The Banks – Phase 3C
Public Infrastructure Development
Bid Package #2 – Lot 28 Park & Garage
January 13, 2022
THP #98090.40

ADDENDUM #2

PARK DETAILS

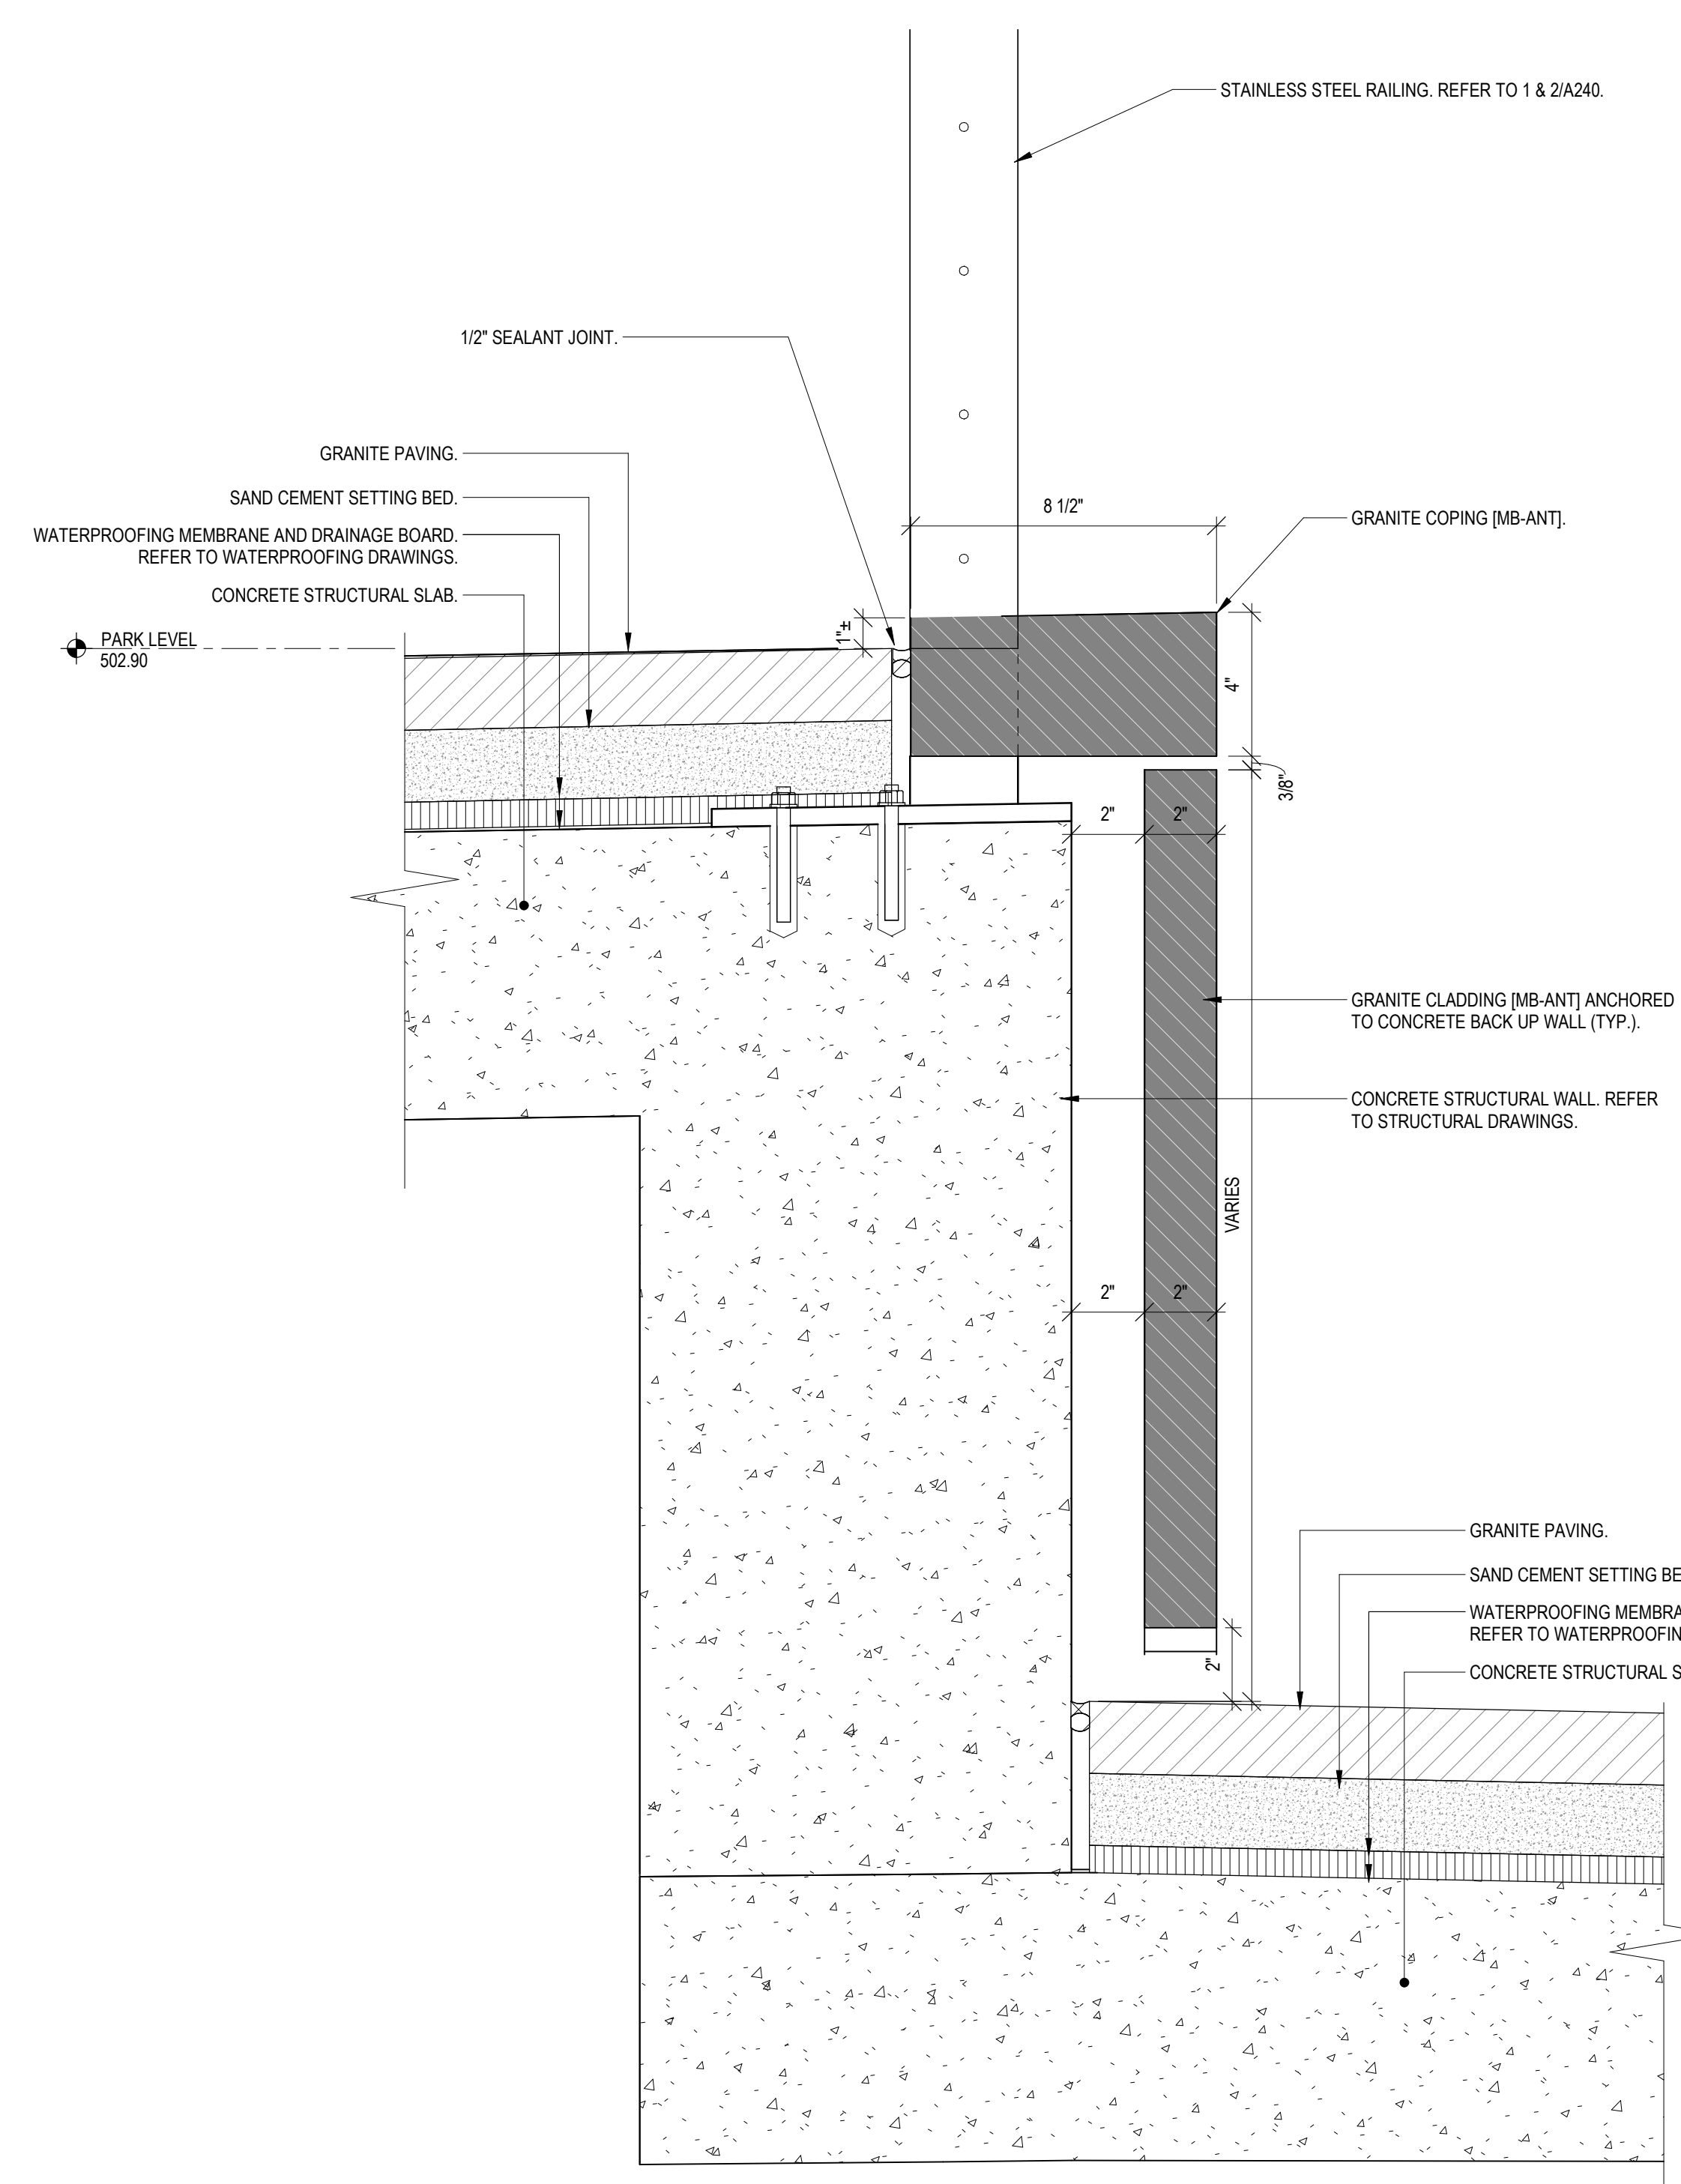
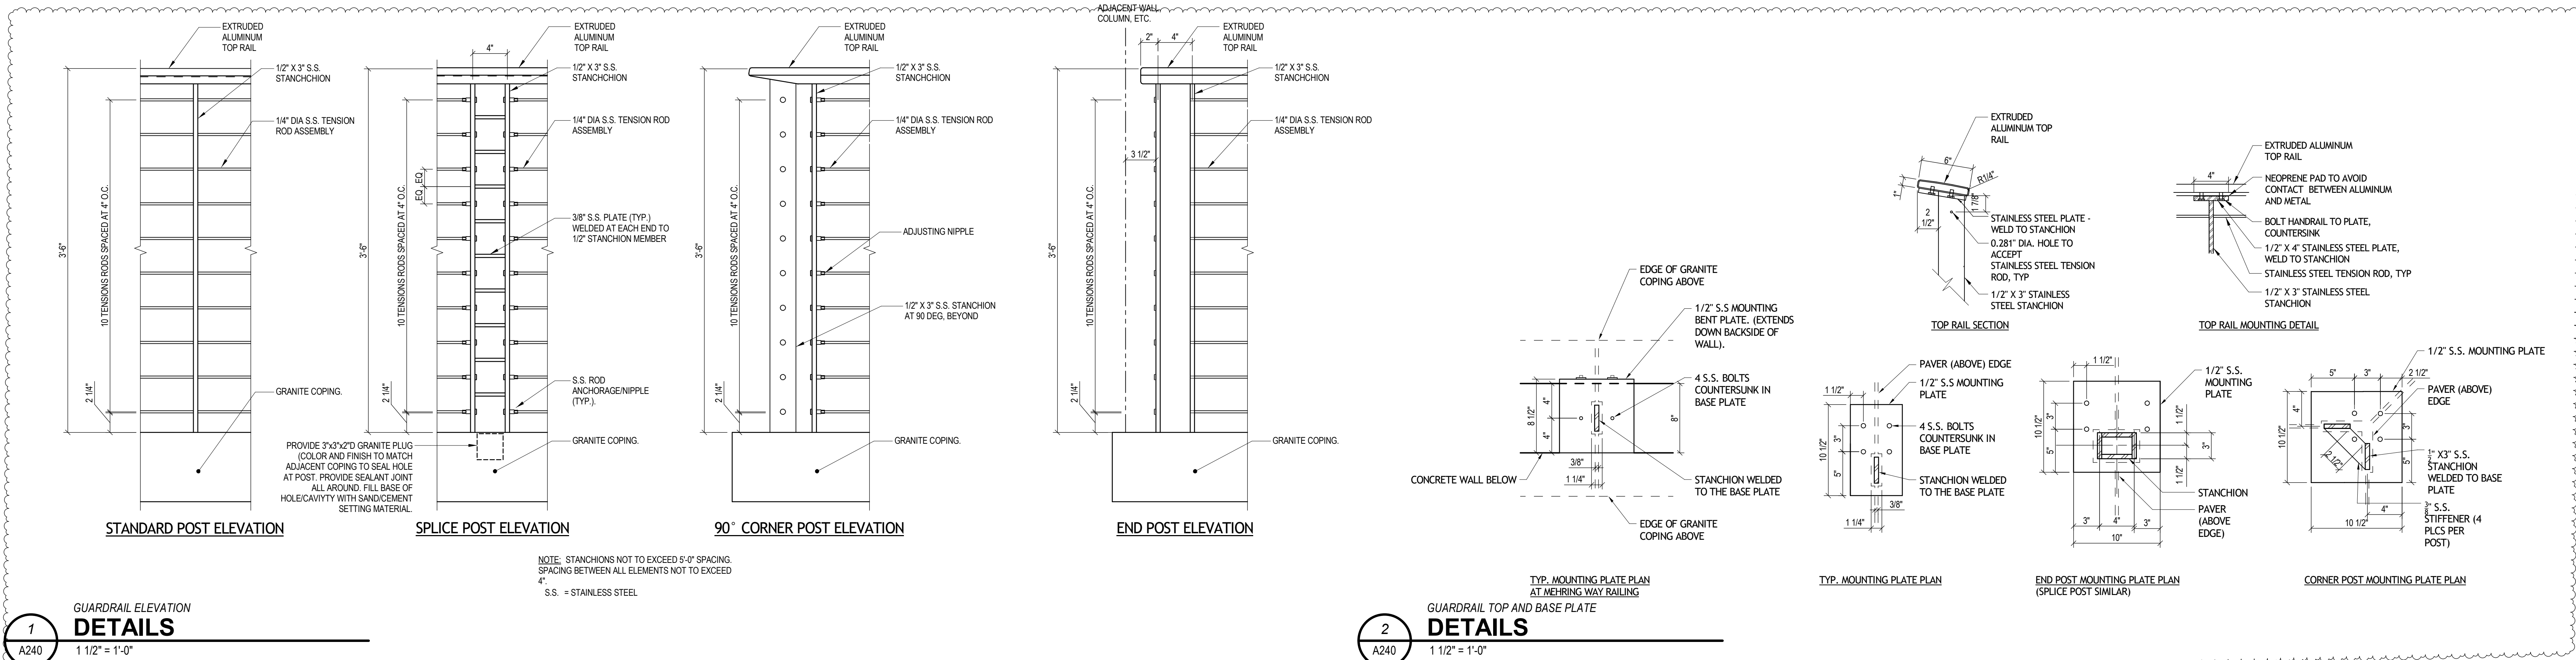
10. **A230** – Please provide detail 7/A230.
 - **Response to question 10:** See revised Drawing A230 in Addendum #2.
11. Please confirm that all third party testing agencies are hired and paid for by the owner including the third party testing agency for monitoring the settling plates.

17. Drawing A206, revised in Addendum #1, references a detail 7/A230. There s not a detail 7 on A230. Please provide.

- **Response to question 17:** See revised Drawing A230 in Addendum #2.

1. **Drawing C102.1:** (Sheet Reissued)
 - Revised Rim elevation M100.
 - Revised Mehring Way clean out elevation.
 - Revised Elm Street clean out elevation.
2. **Drawing C103:** (Sheet Reissued)
 - Revised grading in landscape areas.
 - Wall extended 7' west on radial line 5, revised grading at wall/landscaping.
3. **Drawing A002:** (New Sheet Issued)
 - Revised drawing per clouded areas.
4. **Drawing A101:** (Sheet Reissued)
 - Revised drawing per clouded areas.
5. **Drawing A102:** (Sheet Reissued)
 - Revised drawing per clouded areas.
6. **Drawing A202:** (Sheet Reissued)
 - Granite finish clarifications and updates.
7. **Drawing A220:** (Sheet Reissued)
 - Bollard detail removed/replaced.
 - Shading updated.
8. **Drawing A230:** (Sheet Reissued)
 - Details revised, see drawing per clouded areas.

FOUNTAIN & LOWER LANDING DISPLAY
1 ENLARGED PLAN
1/4\" = 1'-0"

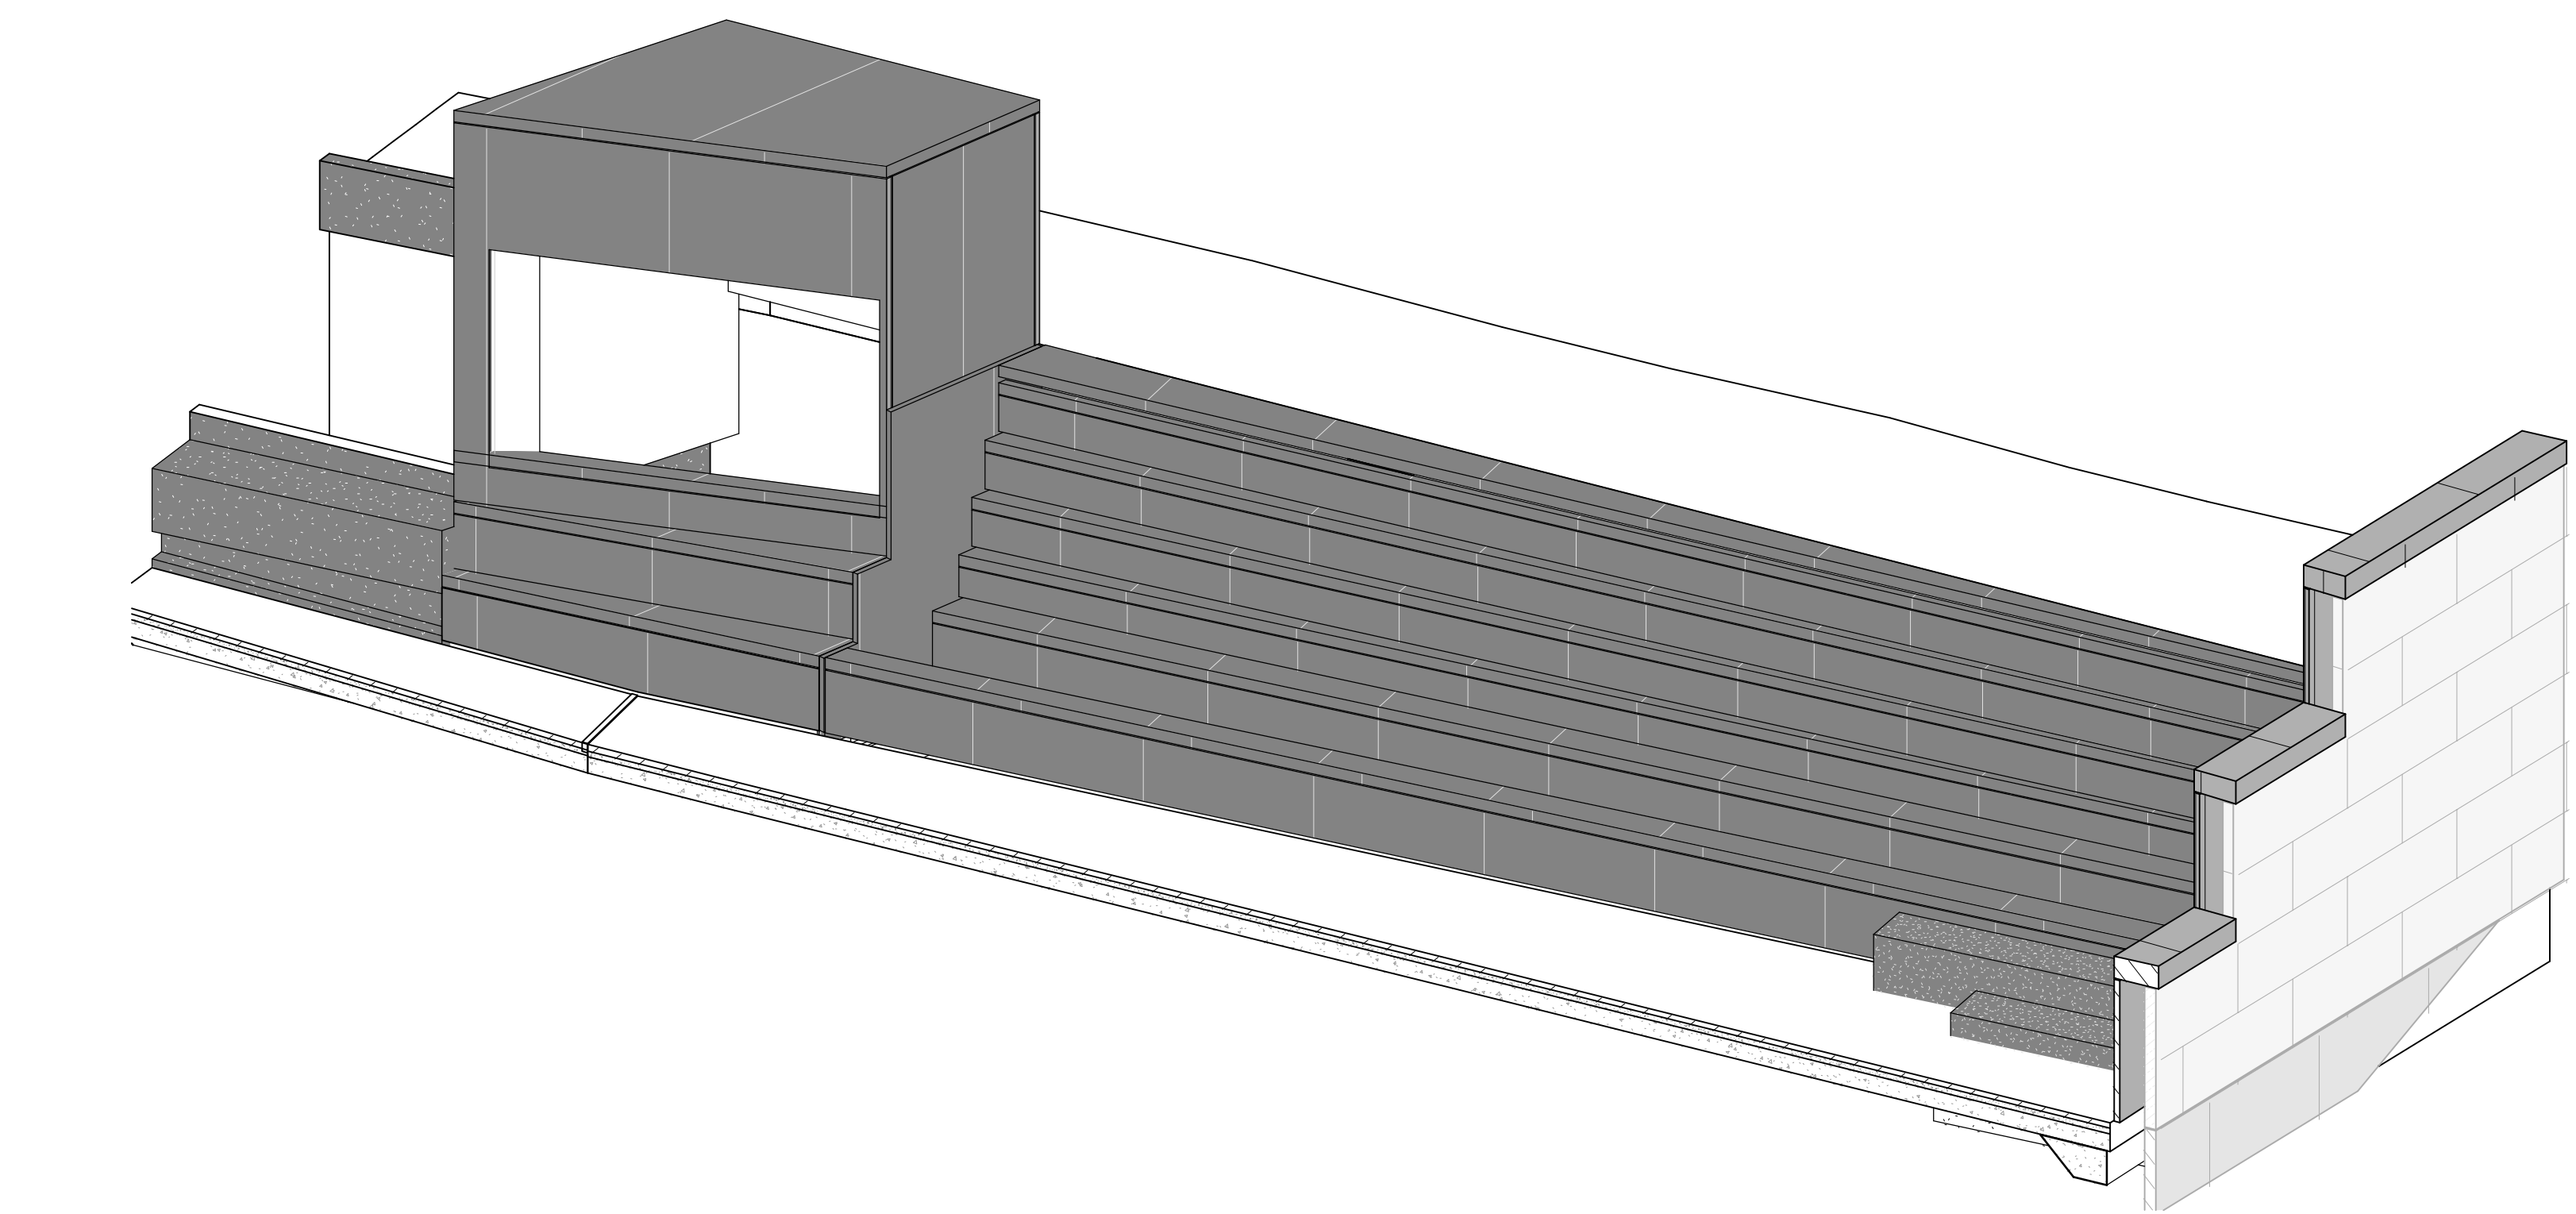
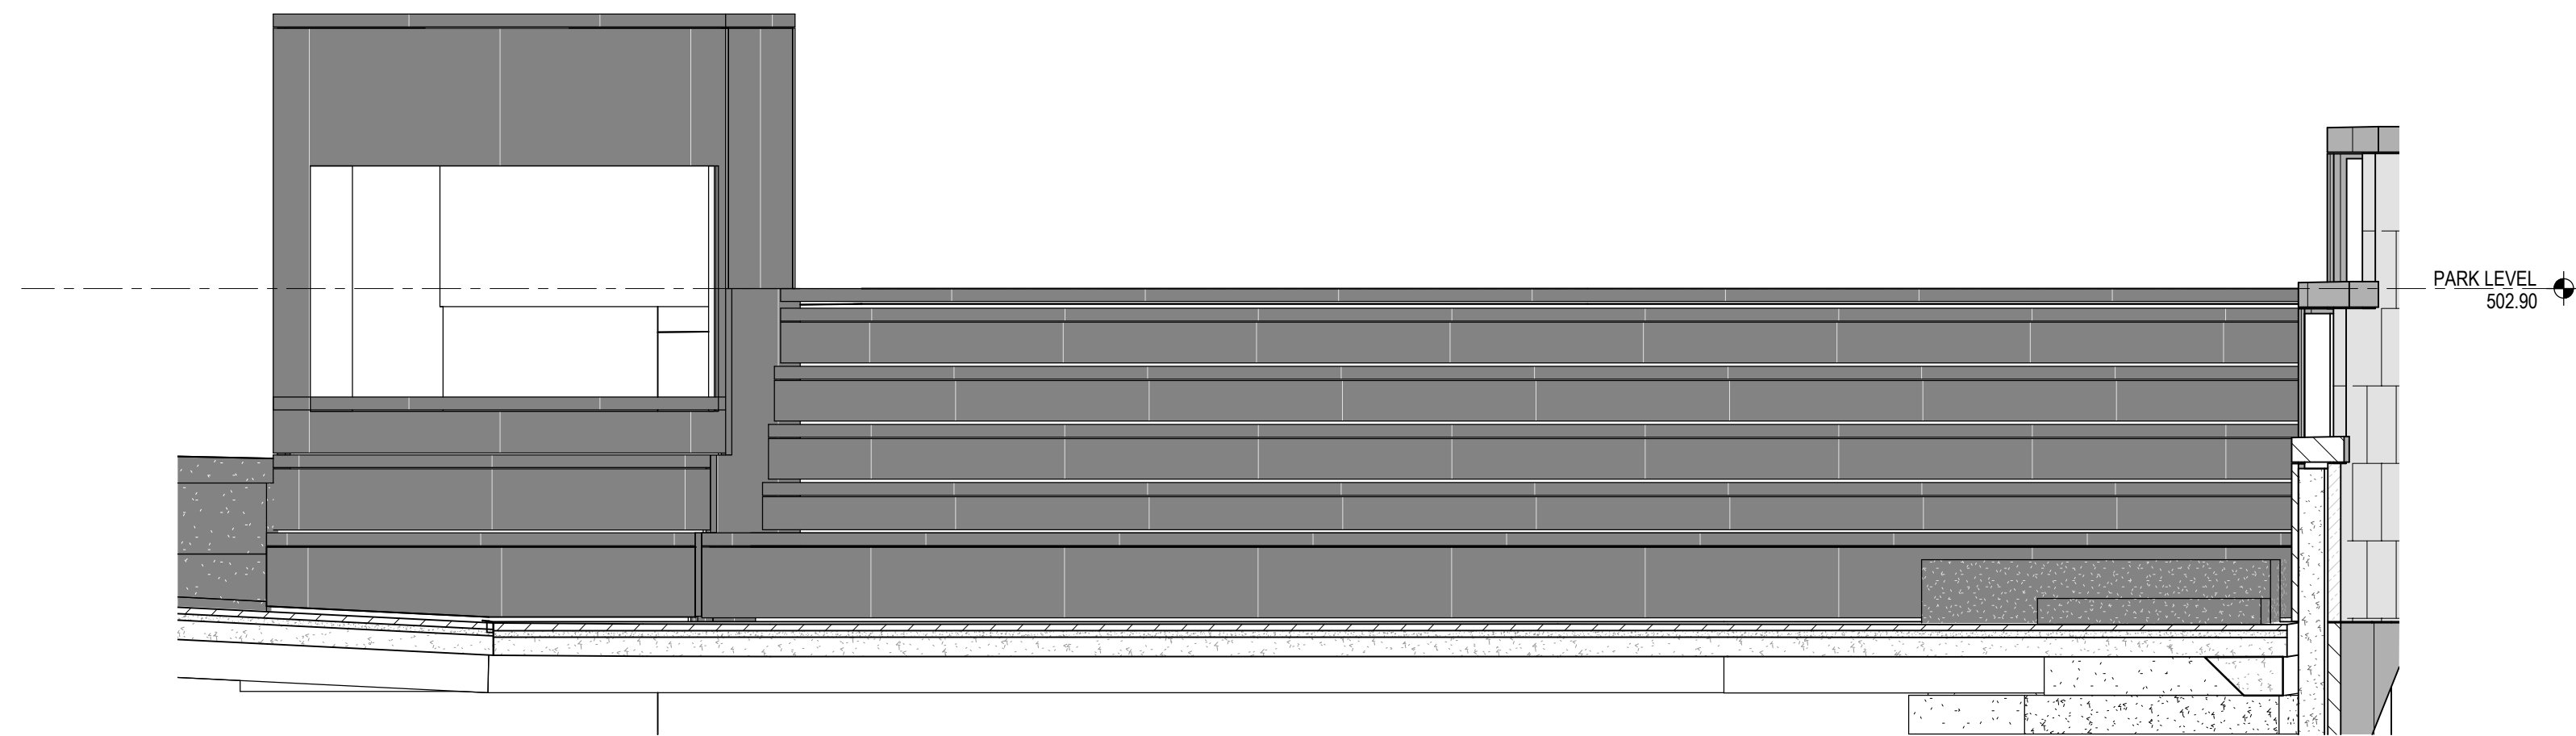
1. **A350** – Drawing A102 has a blow-up drawing noted, 1/A350 at granite clad display area. A 350 is not in drawing packet. Can you please provide.
 - **Response to question 1:** See new Drawing A350 in Addendum #2.

5. **A510.1** Detail 2/A510.1 depicts a granite structure to the east of the of the viewing screen structure. Please provide details for this area?
 - **Response to question 5:** See new Drawings A350, A351 & A352 in Addendum #2.

20. **Drawing A341:** (Sheet Reissued)
 - Granite finish clarification and geometric updates per clouded areas.
21. **Drawing A350:** (New Sheet Issued)
 - Fountain and Lower Landing Display.
